**Collective amendments - UN Regulations Nos. 48 and 123**

### **Proposal for Collective amendments to Regulations Nos. 48 and 123**

#### **Submitted by the expert from the Working Party "Brussels 1952"\***

#### "Annex 14

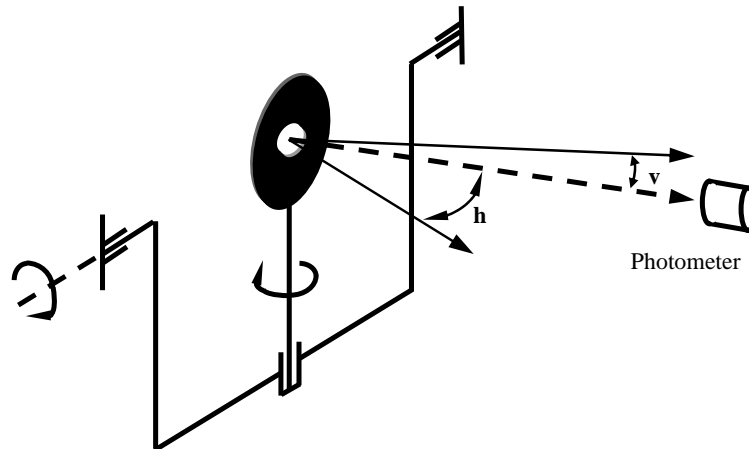
Add a new paragraph 2.34., to read:

"2.34. **Gonio(photo)meter system (If not otherwise specified in a particular Regulation)** means a system used for the photometric measurements specified by the angular coordinates in degrees on a sphere with a vertical polar axis according to CIE publication No. 70, Vienna 1987, i.e. corresponding to a gonio(photo)meter system with a horizontal ("elevation") axis fixed to the ground and a second, moveable ("rotation") axis perpendicular to the fixed horizontal axis (see Annex 14 to this Regulation). Note: The above mentioned CIE publication specifies a procedure to correct the angular coordinates in the case where an alternative gonio(photo)meter system is used."

**Gonio(photo)meter system used for the photometric measurements as defined in paragraph 2.34. of this Regulation:**
